March 31, 1958

#510354 Bumper Band cancelled and superseded by #203290 Bumper Head -
Magneto Assembly Number

Figure 1

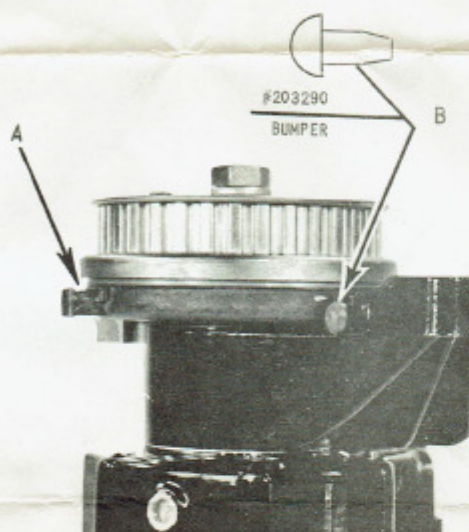
Bumper Band #510354 formerly located at position "A" of the magneto assembly has been cancelled and replaced by bumper head - shown at position "B" - Figure 1.

Figure 2

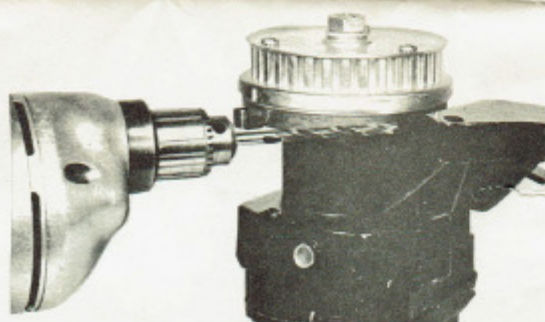
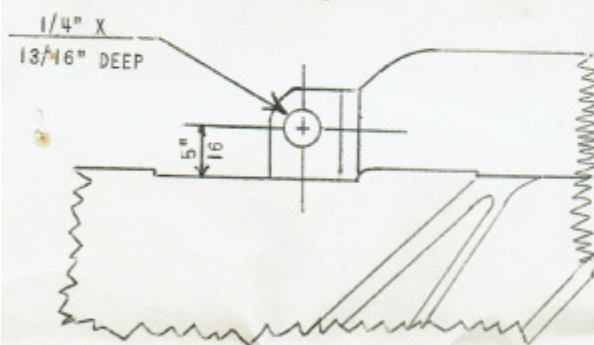
To make the modified replacement, drill a 1/4" hole 1-3/16" deep in the magneto mounting bracket as shown Figure 2.
